# UNITED STATES PATENT AND TRADEMARK OFFICE

APPLICATION NO.	FILING DATE	FIRST NAMED INVENTOR	ATTORNEY DOCKET NO.	CONFIRMATION NO.
10/604,528	07/29/2003	JEN-SHOU TSENG	9499-US-PA	1527

# Office Action Summary

## **DETAILED ACTION**

Gumb discloses a pushbutton for electronic device [Figure 2] comprising:

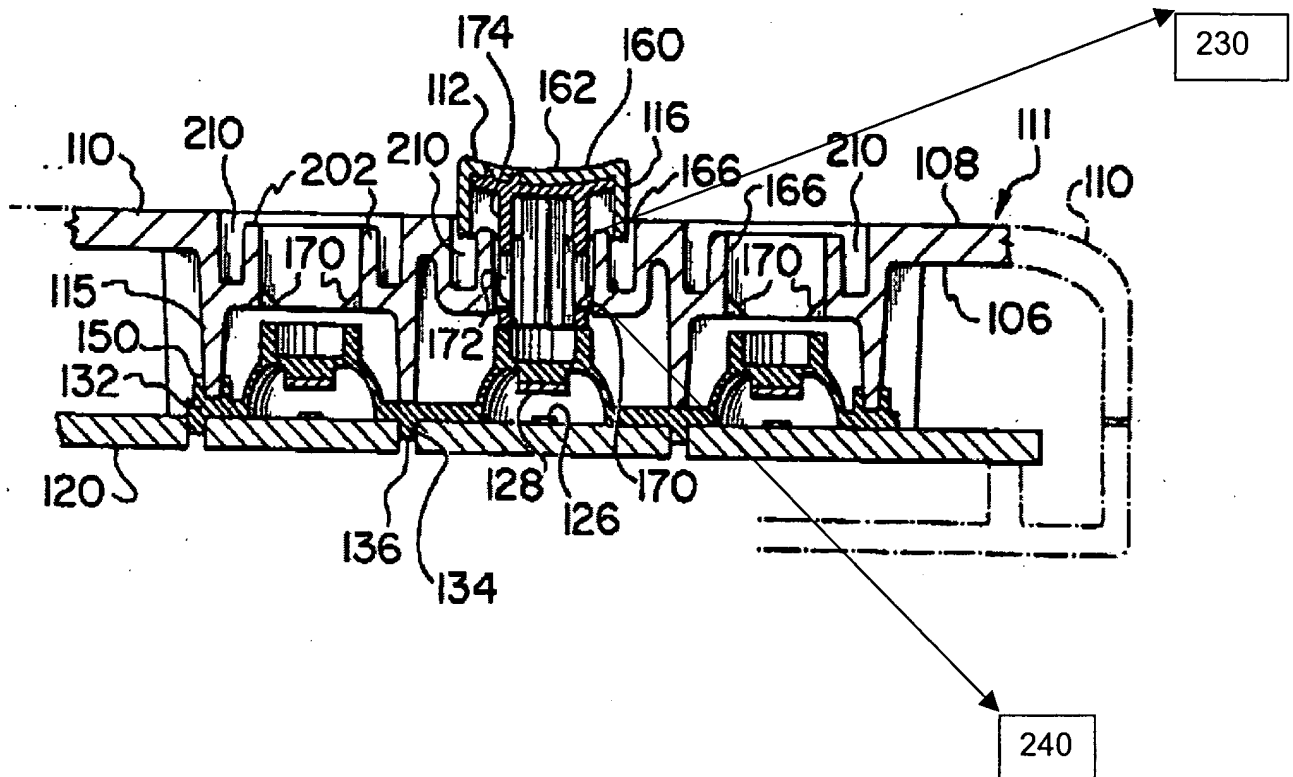
- a housing [110];
- a button cover [160];
- a circuit board [120];
- a button body [174], a wing plate [210], a positioning plate [part of 132; Figure 2]; a contact rod [215].

Gumb discloses all the limitations of claimed invention including the dimensional relationship satisfying the equations:

$$E - B > D; \quad E - D > A; \quad D > A; \quad A \geq C; \quad A \geq B \text{ and } C \geq B.$$

- the dimension B is height from the bottom of the contact rod to the contact point on the circuit board [distance between point 128 and 126];
- the dimension C is height from the bottom of the button body to the outer surface of the housing [distance between point 128 and 126];
- the dimension A is height of the wing plate;
- the dimension D is height of the sidewall of button cover next to the button body (dimension between 230 and 240),
- the dimension E is height from the top of the button body [top of 112] to top end of the wing plate.

Regarding Claim 7, the positioning plate, the wing plate and contact rod assembled in a single unit (integrative unit). Regarding Claim 8, the contact rod and button body are separately made. Regarding Claim 9, the wing plate disclosed is elastic.
